RE: 1400-1500 W. Dundee Rd., Arlington Heights – Review Letter Response

Arlington Heights, Illinois (Cook County)

PEG Job No.: 2283.00-IL

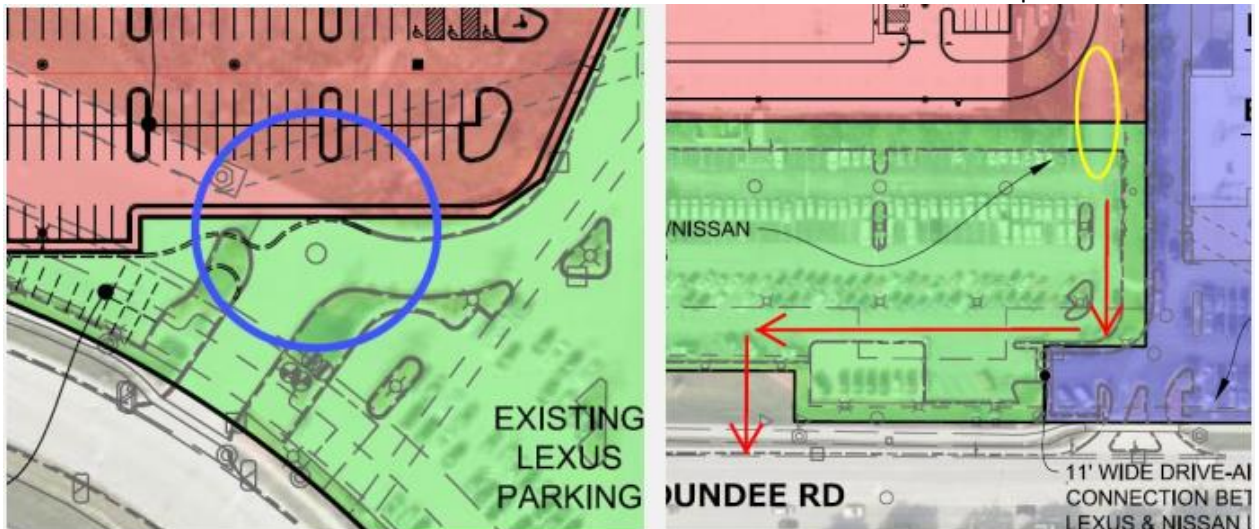
54. The response to comment #31 is not acceptable. Please either provide a detailed and scaled floorplan showing the interior of the remaining spaces within the Lexus building post-demolition, or provide the specific info as highlighted in the table below, which is necessary for the Village to re-calculate the parking requirement.

Response by Lexus project team representative: This information has been included on sheet C2.0 of the JCA site engineering plans.
